=====
PennDOT BQAD Publications e-Notification
Bureau of Design
Bridge Quality Assurance Division
=====

Publication No. 218M & 219M
Standard: All Current
RE: Linked PDF files
No. 14
Date: 1-29-07 w/ 11-28-07, 4-24-13 & 12-30-13 updates

PennDOT e-Notification No. 30

Interim Revision to Bridge Standard Drawing(s)	BD-601M, "Concrete Deck Slab", Sheet 4, dated 9/20/2010. Sidewalk Cross slope and reinforcement revisions.
--	--

TYPICAL SIDEWALK DETAIL

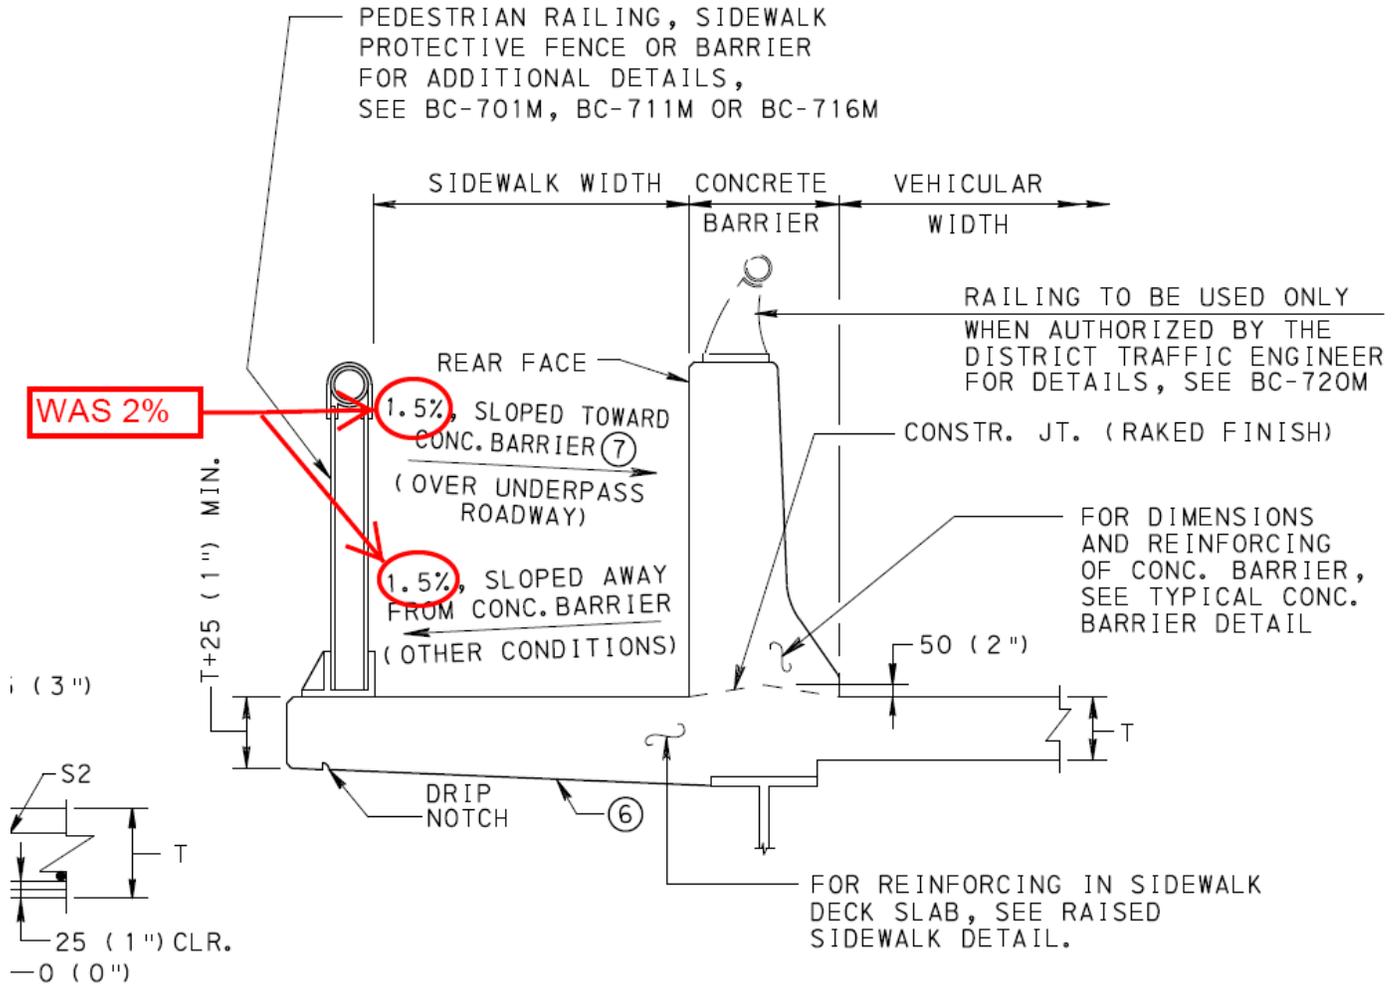
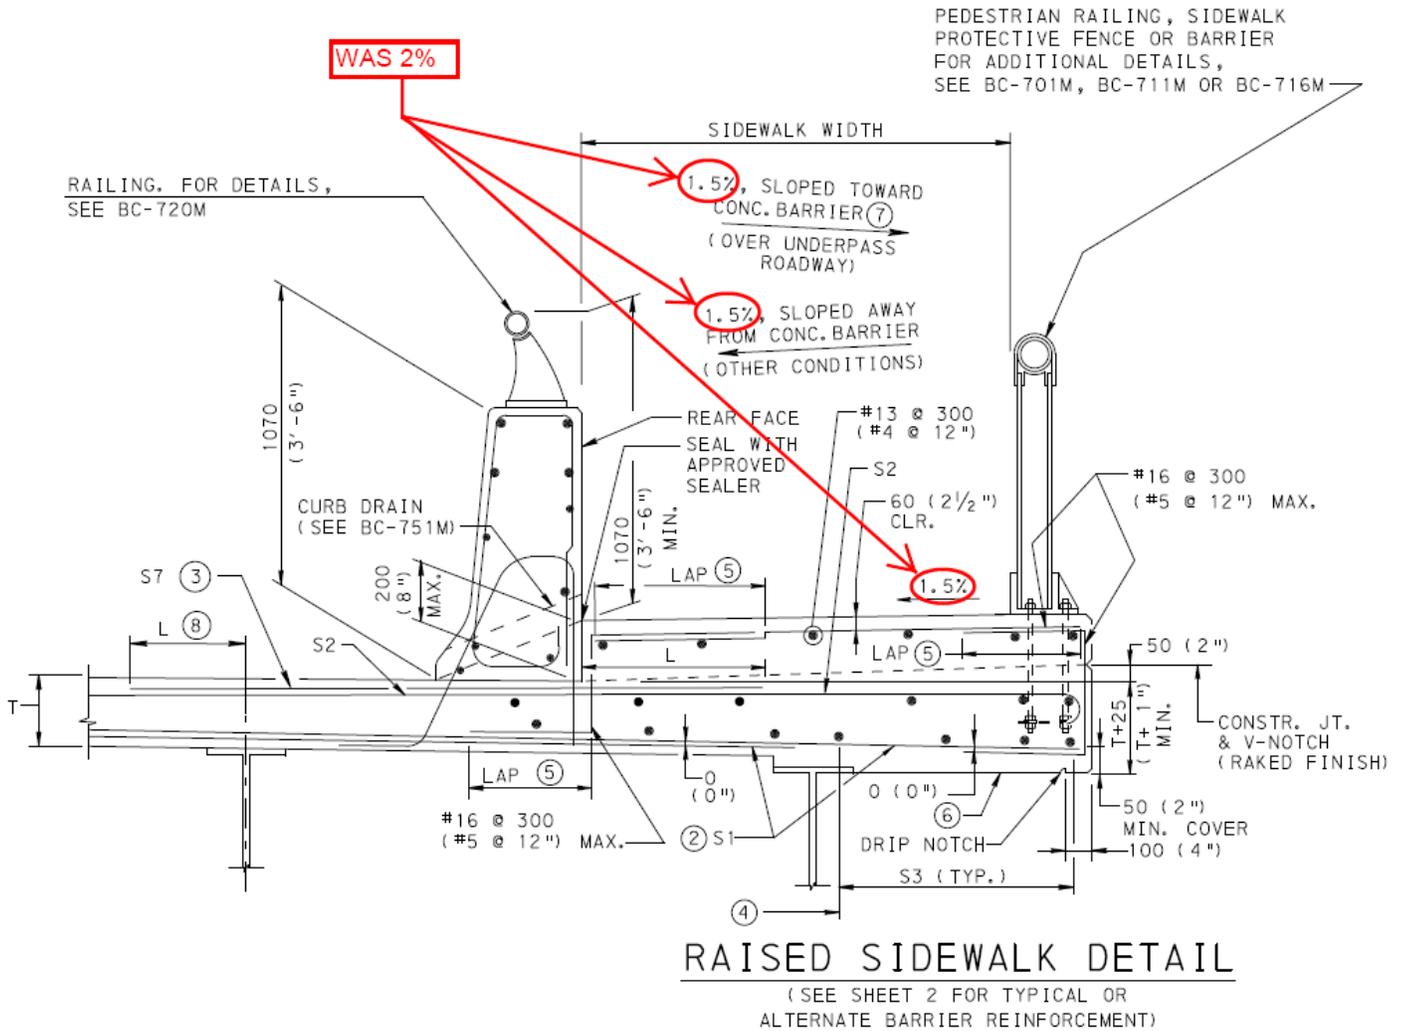
1. TYPICAL SIDEWALK DETAIL – cross slope changed from 2% to 1.5% in two call-outs.
2. RAISED SIDEWALK DETAIL – cross slope changed from 2% to 1.5% in three call-outs.
3. ALTERNATE SIDEWALK DETAIL – cross slope changed from 2% to 1.5%. The 180 degree hook is being eliminated from end of transverse reinforcement.

BD-613M, Sheet 11

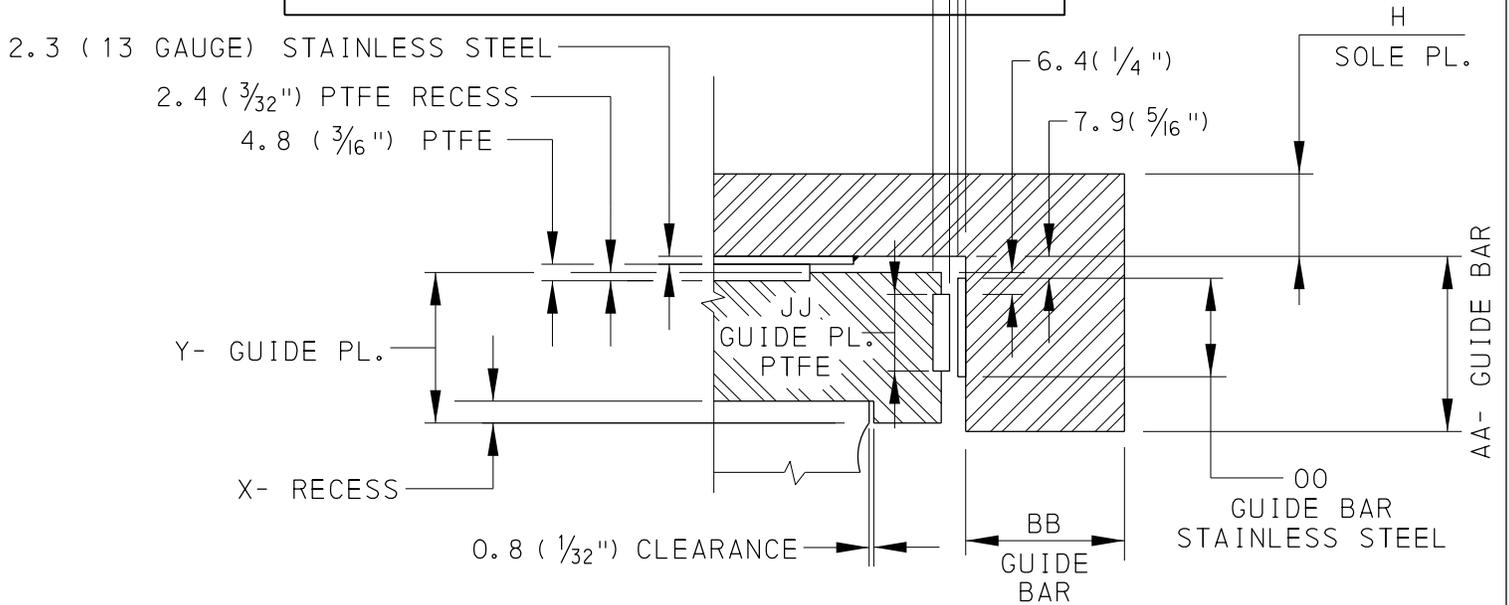
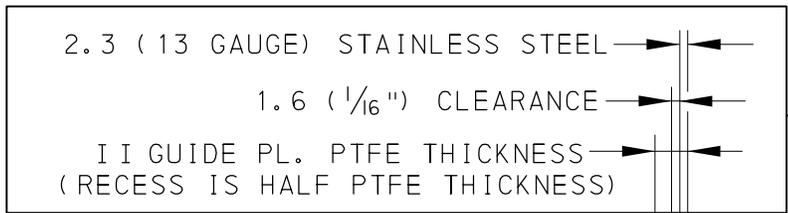
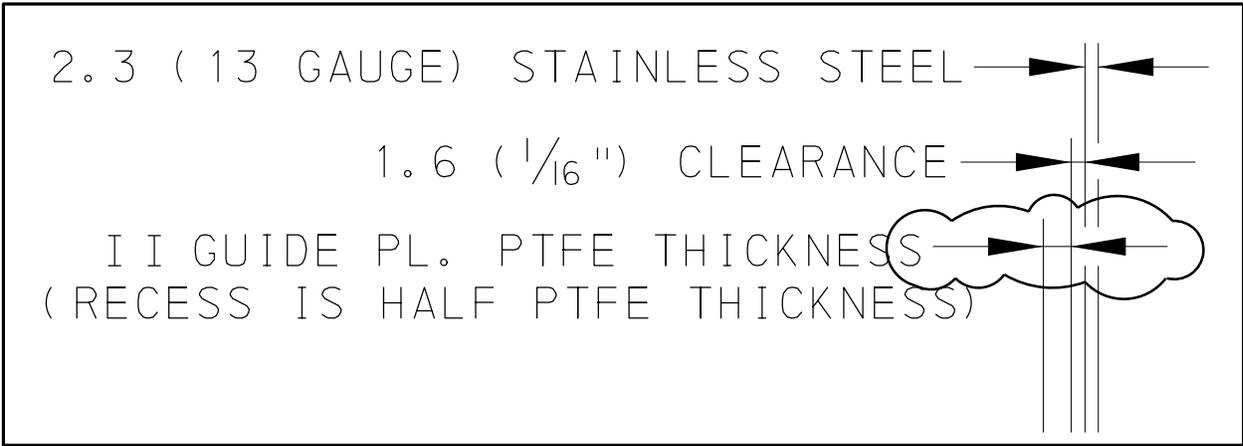
Sheet 11, DETAIL A: Add a note to 1/8" MIN. edge distance using "*" which states it may be reduced to zero in order to eliminate blasting and painting of small edge area as long as the quality of weld is not compromised.

* 1/8" MIN MAY BE REDUCED TO ZERO IN ORDER TO ELIMINATE BLASTING AND PAINTING OF SMALL EDGE AREA BENEATH SOLE PLATE AS LONG AS THE QUALITY OF WELD IS NOT COMPROMISED.

BD-613M, SHT. 13
(MAY 16, 2012)

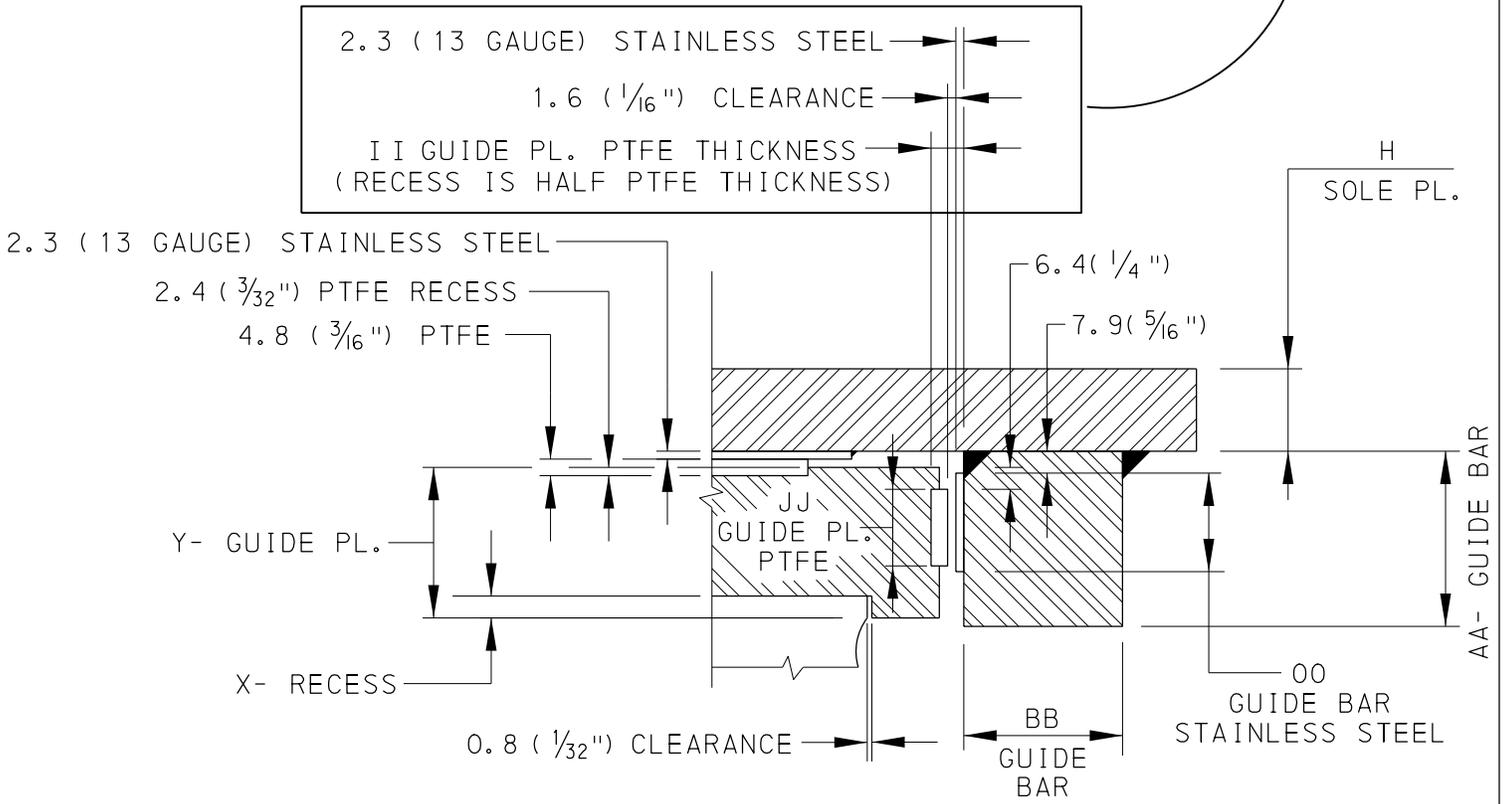
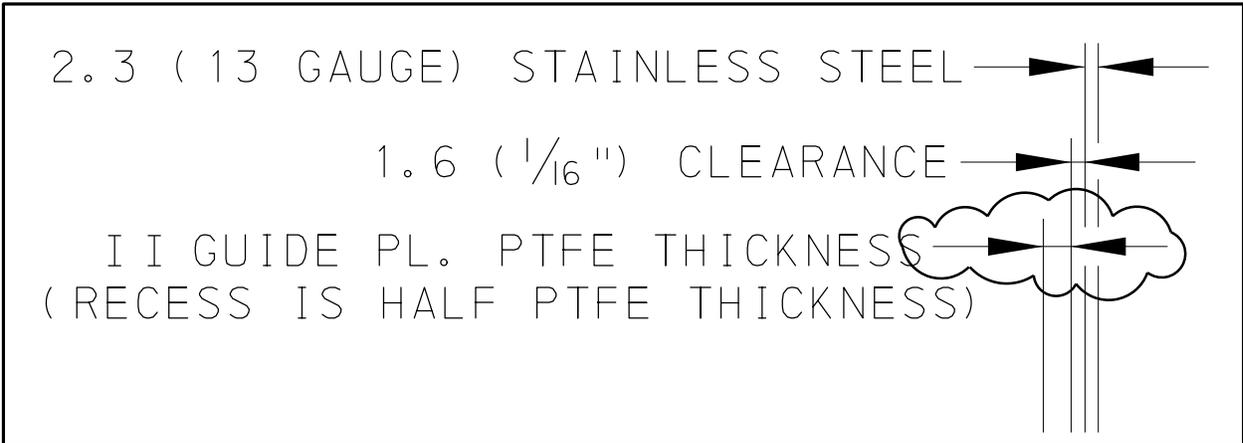
Sheet 13, ALTERNATE GUIDE BAR FABRICATION DETAIL and DETAIL B: Correction of dimension arrowhead locations for the II GUIDE PL. PTFE THICKNESS.

BD-622M, SHT. 1
(MAY 31, 2012)

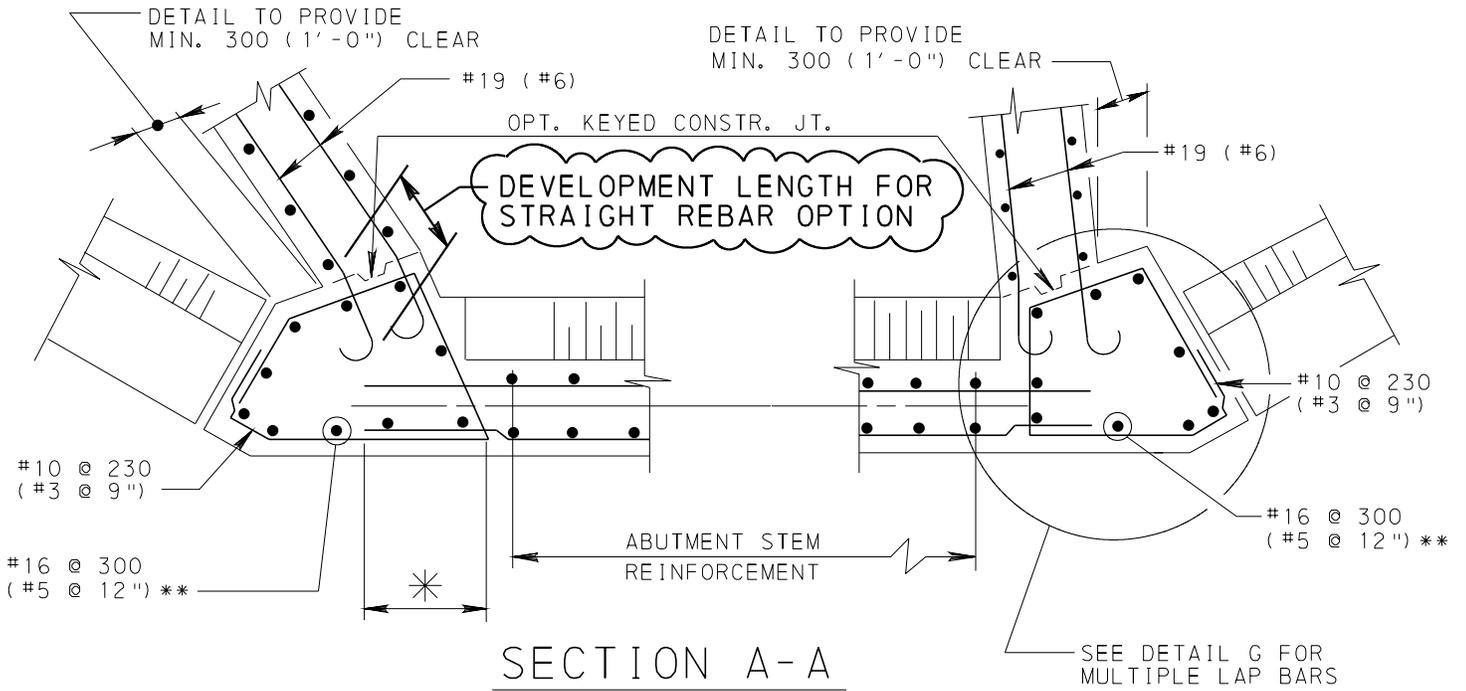
Add "DEVELOPMENT LENGTH FOR STRAIGHT REBAR OPTION" call-out to abutment section A-A as shown on attachment.

TYPICAL EXPANSION/RELIEF JOINT

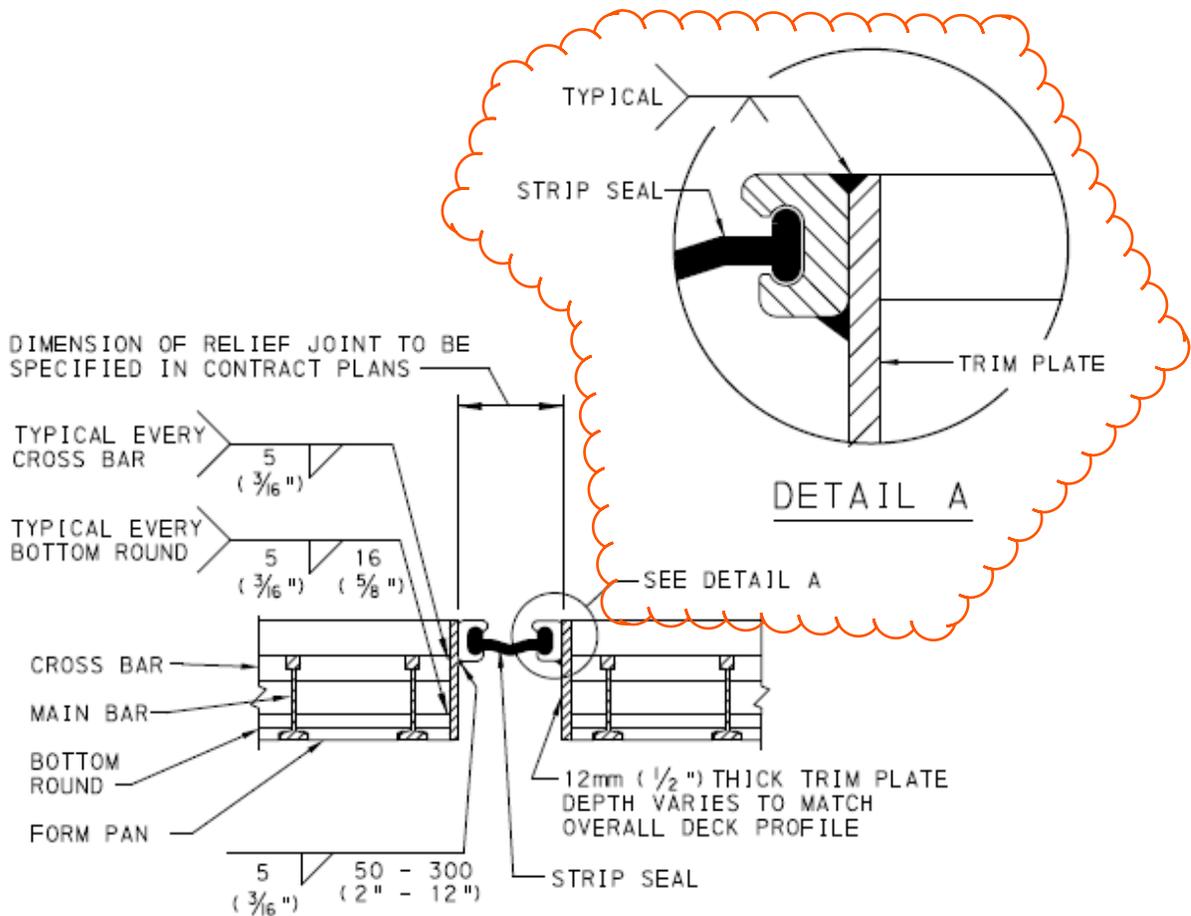
Fillet weld replaced by groove weld to allow strip seal extrusion to be positioned flush with top of bridge deck.

SECTION F-F

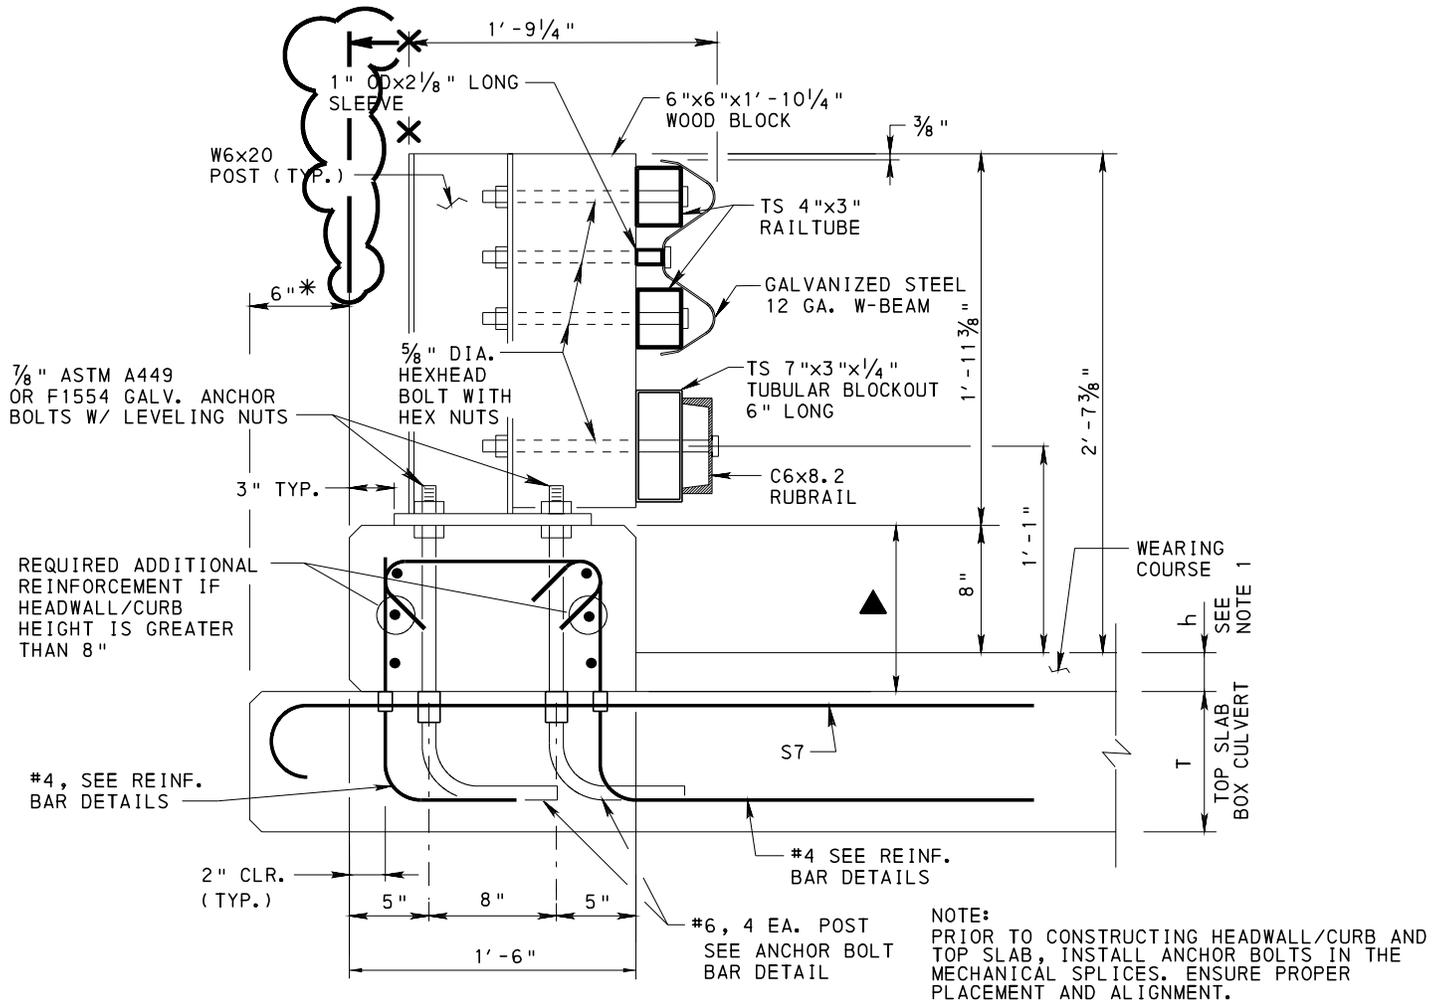
Corrected dimension to indicate distance from front face of W-beam to rear face of headwall/curb. This dimension had been properly indicated on other details.

e-Notification No. 40
BD-632M, SHT. 5 (AUGUST 31, 2012)
EDITED EXISTING NOTES RELATED TO ROCK LINING AND ALTERNATIVE CUTOFF WALL

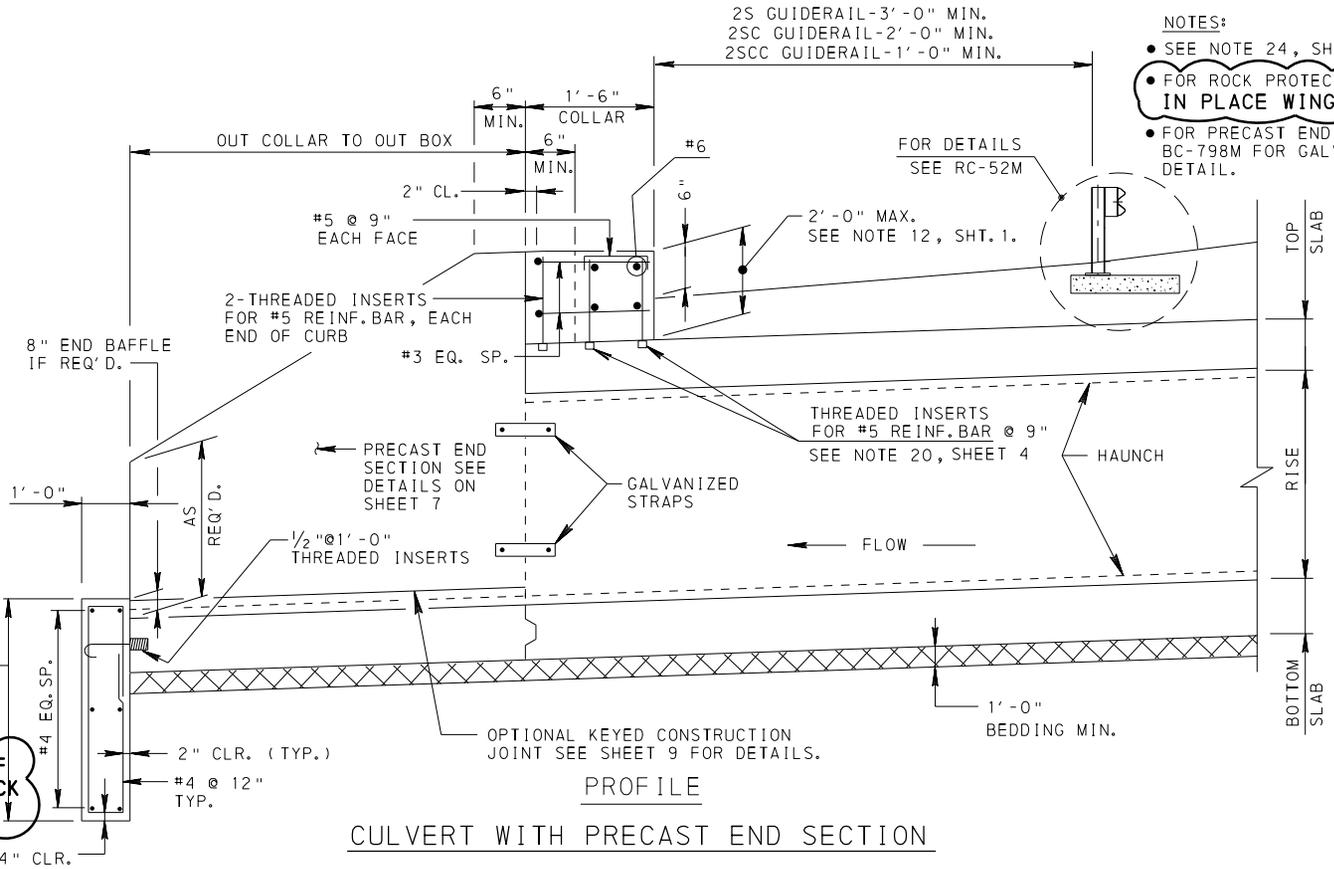
An alternative cutoff wall with grouted rock detail is being added to the box culvert standard.

AN ALTERNATIVE CUTOFF WALL WITH GROUTED ROCK IS PERMITTED, SEE DETAIL A ON SHEET 6.
